STATE OF VERMONT AGENCY OF TRANSPORTATION

PROPOSED IMPROVEMENT TOWN OF PERU COUNTY OF BENNINGTON VT ROUTE 11 (MINOR ARTERIAL)

Record Plans

DIRECTOR OF PROJECT DELIVERY	APPROVED DATE 12/31/2014
PROJECT MANAGER : KEN UPMAL, P.E.	
PROJECT NAME : PERU	
PROJECT NUMBER : STP SCR(4)	
SHEET 1 OF 45 SHEETS

PROJECT NAME: PERU  
 PROJECT NUMBER: STP SCR(4)  
 FILE NAME: z07b106bdr.dgn  
 PROJECT LEADER: E. ATKINS  
 DESIGNED BY: M. BRADLEY  
 PLAN SHEET

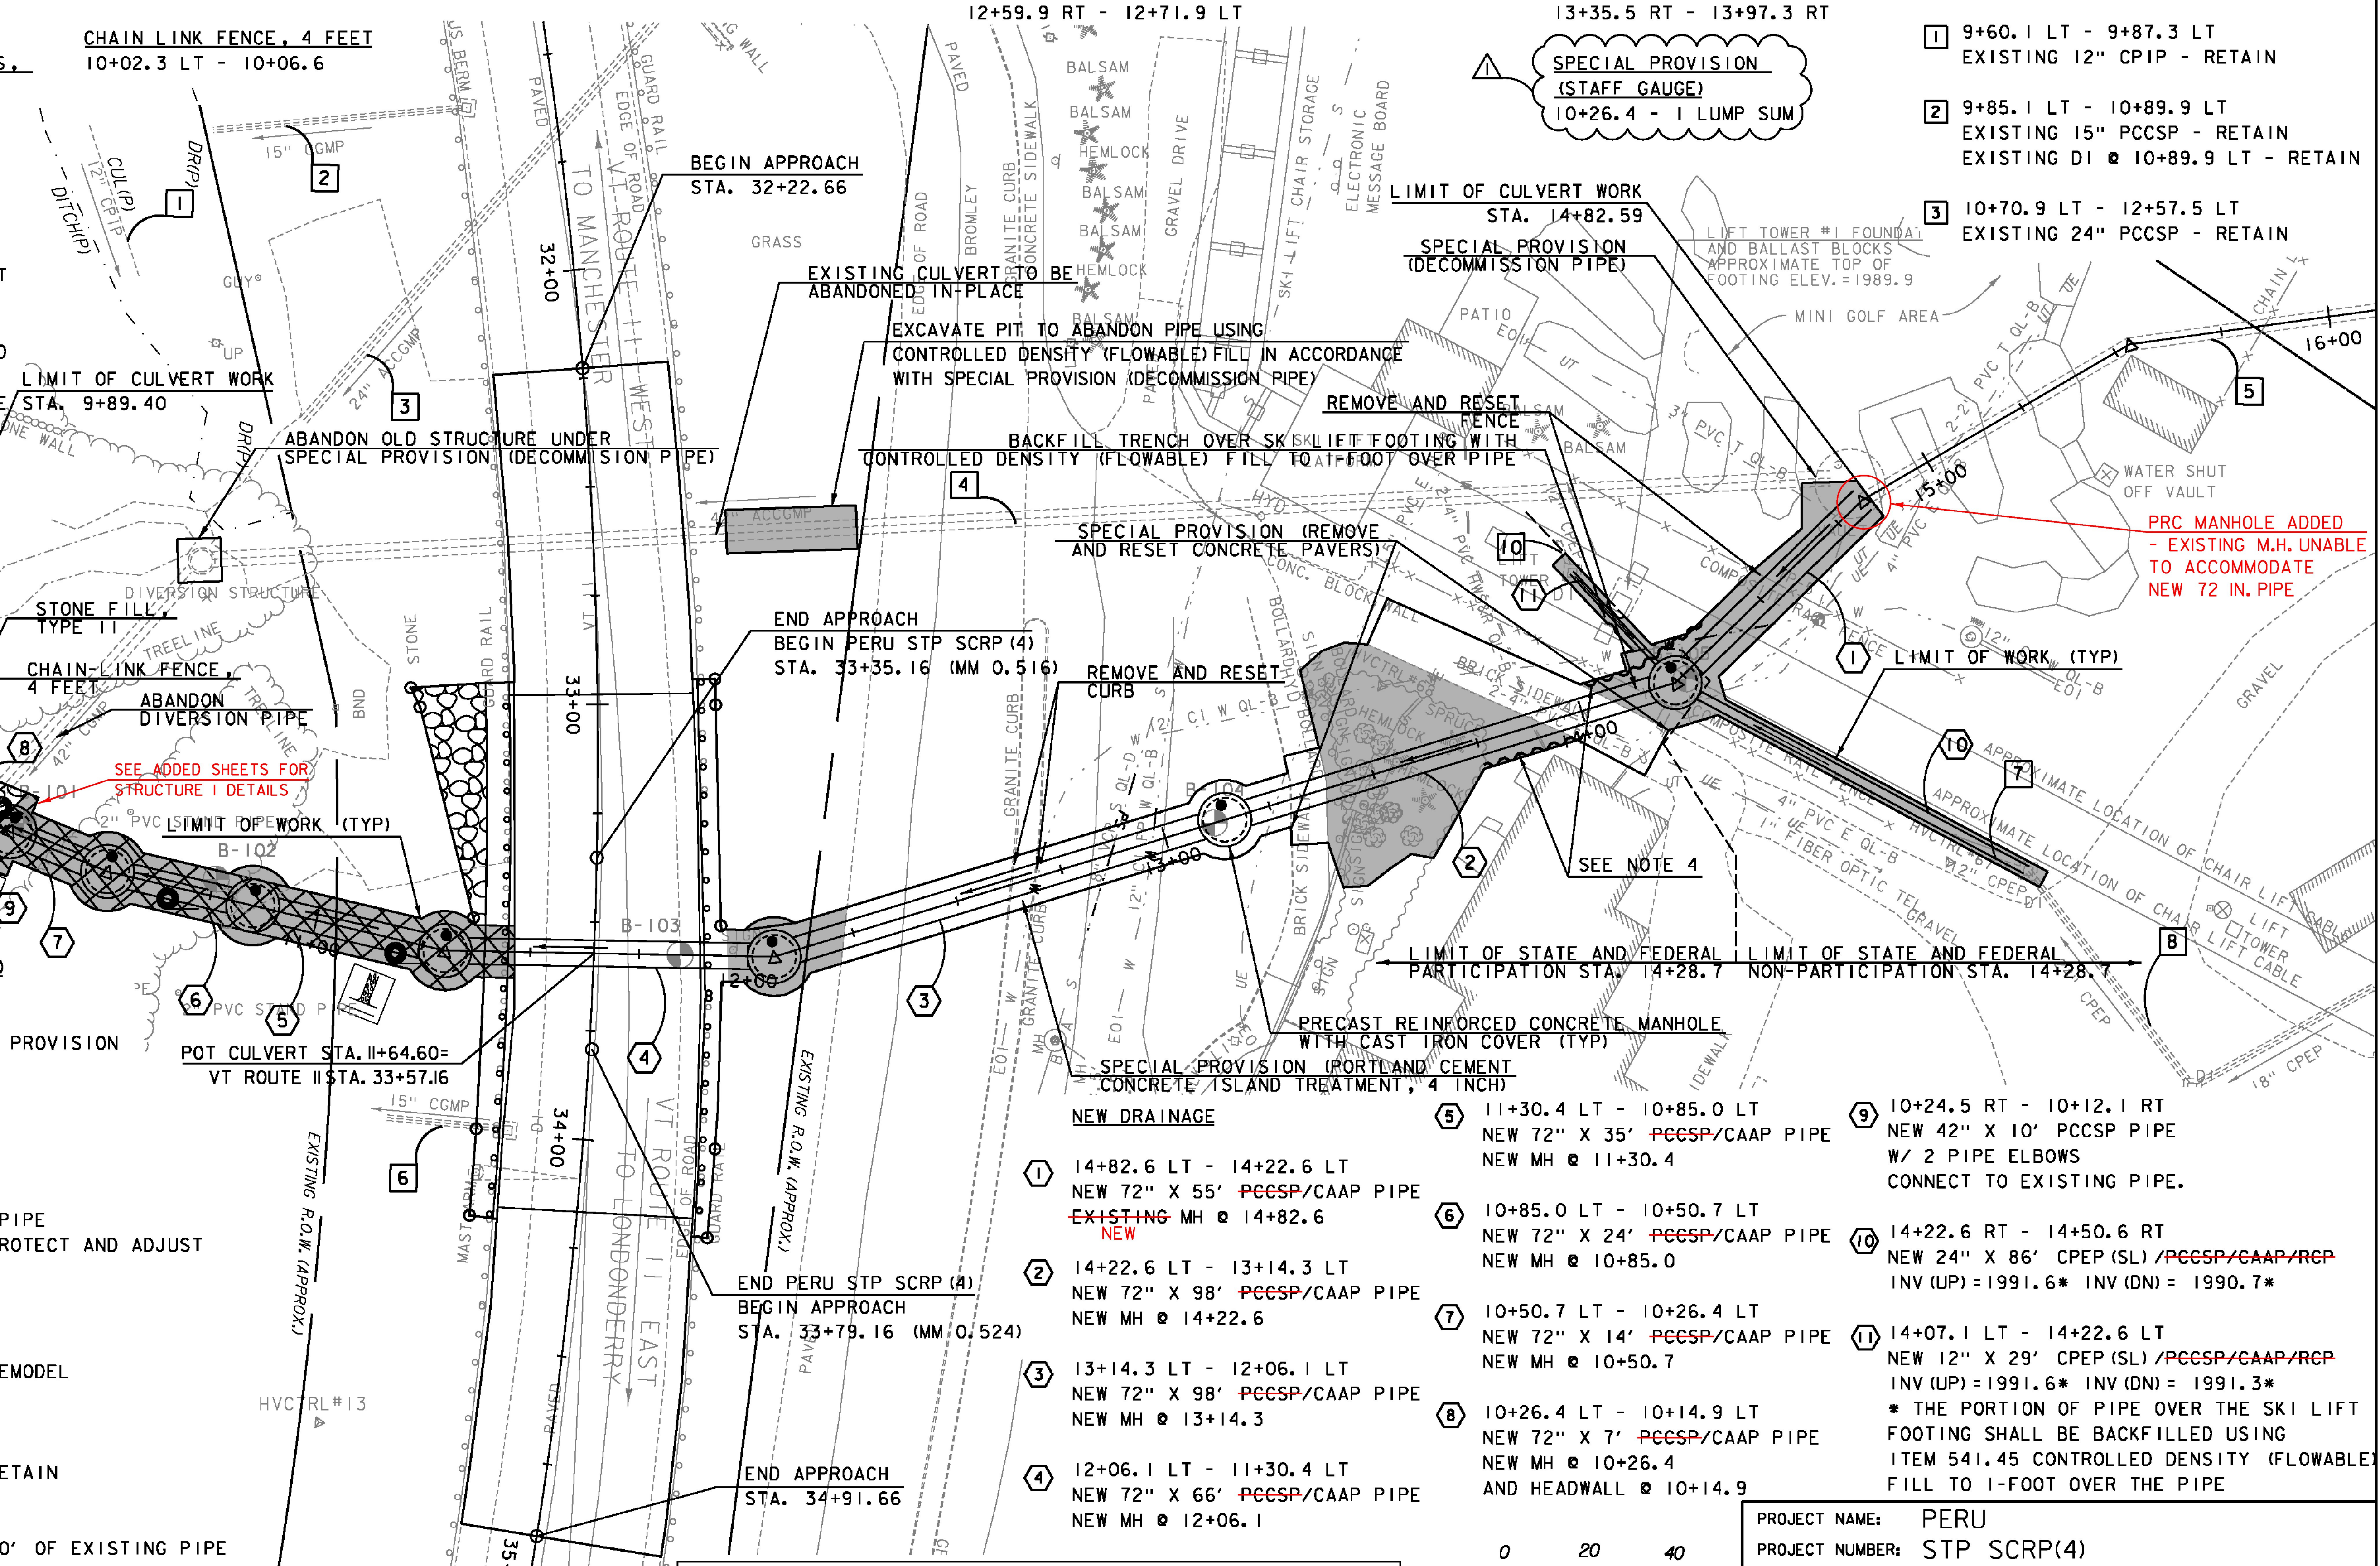
**REMOVE AND RESET GUARDRAIL** **EXISTING RAIL WAS IN POOR CONDITION**  
 32+94.6 RT - 34+19.6 RT  
 32+94.6 LT - 34+19.6 LT

RETAIN EXISTING PIPE  
 WEIR WALL ADDED TO STRUCTURE 1

PRC MANHOLE ADDED - EXISTING M.H. UNABLE TO ACCOMMODATE NEW 72 IN. PIPE

PROJECT NAME:	PERU
PROJECT NUMBER:	STP SCRP(4)
FILE NAME:	z07b106ut11bdr.dgn
PROJECT LEADER:	E. ATKINS
DESIGNED BY:	M. BRADLEY
UTILITY PLAN SHEET	
PLOT DATE:	12/31/2014
DRAWN BY:	M. BRADLEY
CHECKED BY:	E. ATKINS
SHEET	28 OF 45

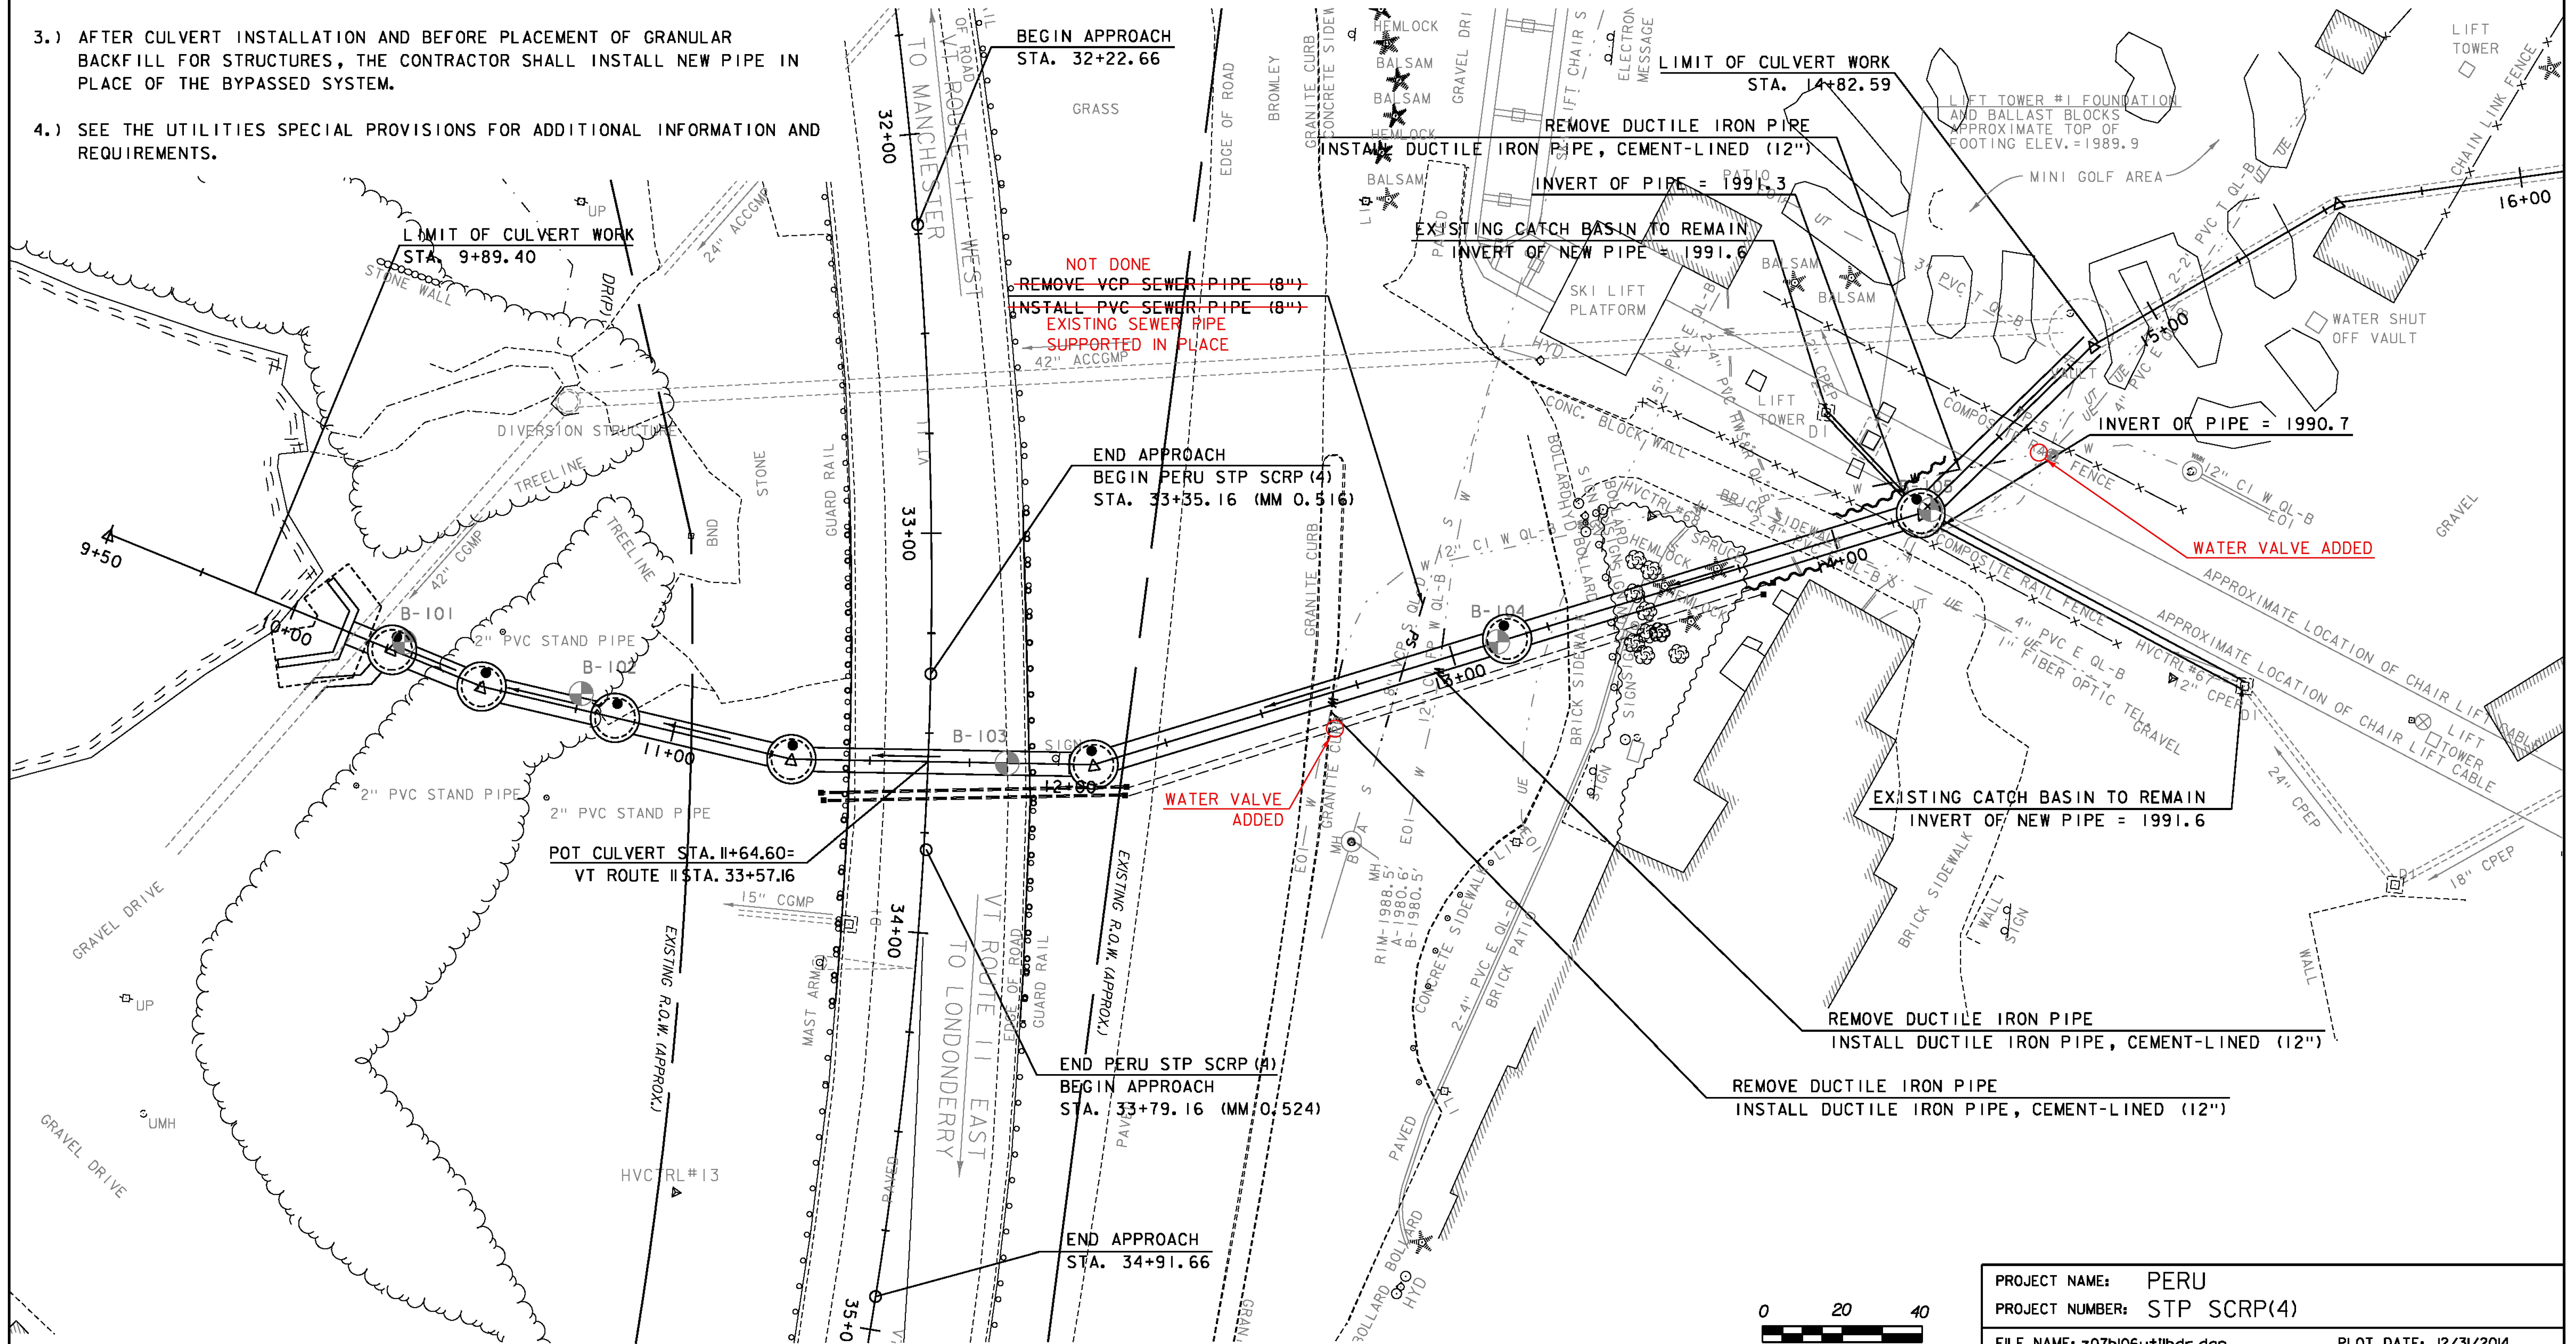
~~PVC SEWER PIPE (8") (PARTICIPATING)~~  
~~12+76.2 RT - 12+97.7 LT NOT DONE~~
